Extreme Engineering 9198-B Ridge Road Newcastle CA, 95658 USA Phone: 916/663-1560 Fax: 916/663-9249 info@extremeengineering.com	Bulletin No:001
		Release Date:04/28/04
		Effective Date:04/28/04
		Supersedes: N/A
		Completion Date:
		Page: 1 of 2
<h1>SERVICE BULLETIN</h1>		
Ride Manufacture: Extreme Engineering	Affected Production Date: All AB-34 and AB-44	
Ride Name: AB-34 and AB-44 auto belays.	Affected Serial Nos.: All	
Model Number: AB-34, AB-44		
Abstract Of Issue:		
Systems must have the proper amounts of fluid to operate safely. To prevent any issues the following bulletin is being sent. The following details must be checked. Any questions, please refer to on-line manuals @ www.extremeengineering.com or contact us at (916) 663-1560.		
<ul style="list-style-type: none"> • Fluid level of tank • Loose and or missing parts • Cable installation • Cable condition • <i>Recommended mounting methods of belay in the box.</i>

SAFETY TIP 11

Anchor Bolt Issue, New Product Update

Fig. 3

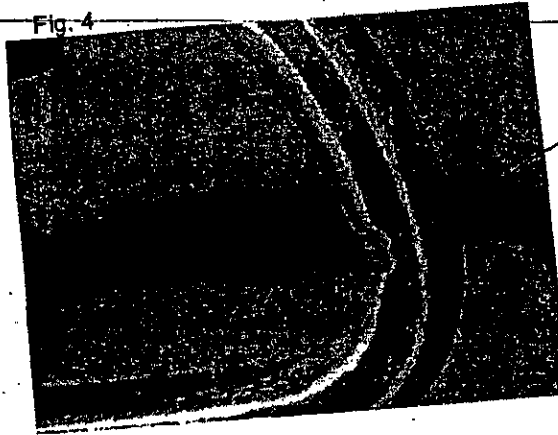
As shown in Fig. 3 you can see how standard climbing anchor bolts create notches in carabiners with their sharp, slotted holes. These anchor bolts are traditionally made for quick-links or webbing for top roping or lead climbing. The anchor bolts were never intended for the auto-belay system. Fig. 4 is the end result of an auto-belay system used on a climbing anchor bolt.

Fig. 5

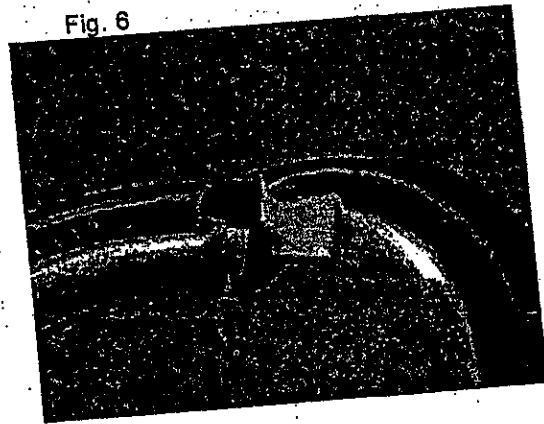
With a notch on the carabiner it can crack or snap in half right at the notch. See Fig. 5 and 6.

Fig. 7

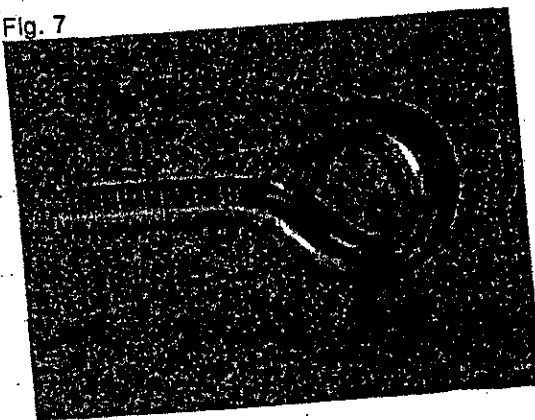
Extreme Engineering's version of a climbing anchor bolt (see Fig. 7) is designed for the auto-belay system. It is bent in a smooth, round circle, minimizing sharp edges and stress towards a carabiner. They install easily into one of your existing t-nuts on your climbing wall. Just screw them, don't forget to apply a washer, and use them when clicking your cables to the wall.
